Recall Campaign Bulletin

Campaign No. 2016030006, April 2016

SUBJECT: Model 906, Model Years 2015 - 2016 Replace Tire Pressure Label

Figure 1

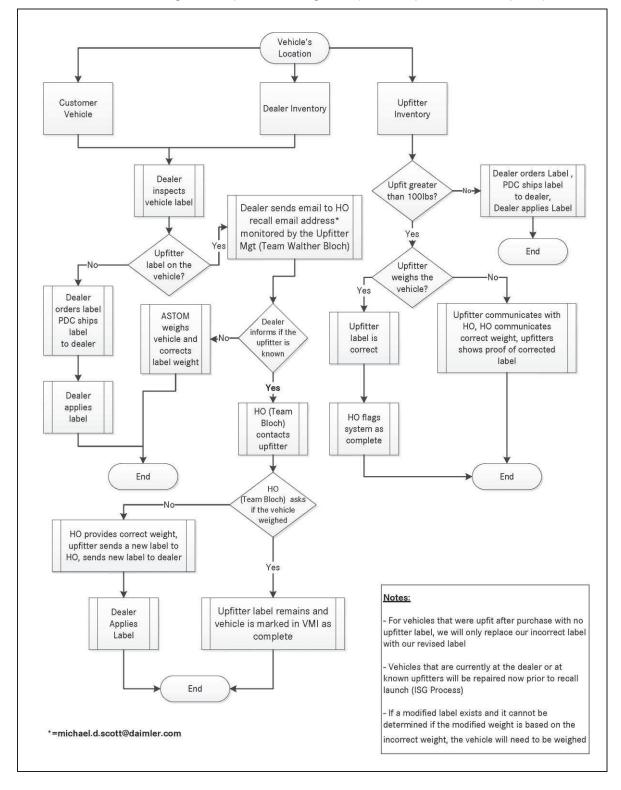
This Recall Campaign has been initiated because Daimler AG (DAG), the manufacturer of Sprinter vehicles, has determined that the subject Sprinter vehicles were equipped with tire pressure labels that indicate an incorrect (higher) maximum load capacity. To remedy this, an authorized Mercedes-Benz dealer will replace the tire pressure label with a new label showing the correct maximum load capacity.

- Replace label (1, Figure 1) and affix protective foil if required.
- Clean vehicle's bonding surface prior to affixing label (if label replacement is required).

Qty.	Part Name	Part Number	Estimated Replacement
			Rate
1	Tire pressure label	A 906 584 66 38 26	100%
1	Protective foil	A 901 584 00 55
